Access Compliance Report Public Rights-of-Way (Curb Ramps)

Main Street: GLENROY_PL Cross Street: SILVER_FOX_RD Location: NW

ADA ID: RPAT211202143507 Ramp Type: Type 1 - Perpendicular Diagonal Initial Pass/Fail: Fail Overall Compliance: No Severity Score: 2

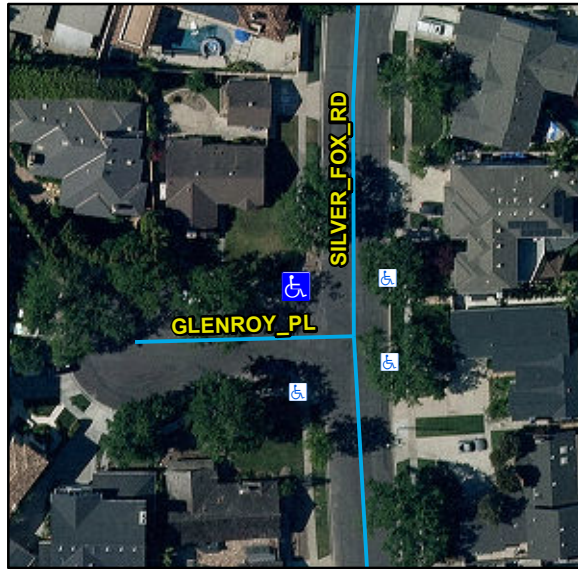
R304.2.2, R204.3, R304.5.3, STD 1115

Remove & Replace Curb Ramp With Two New Directional Ramps or Equivalent.
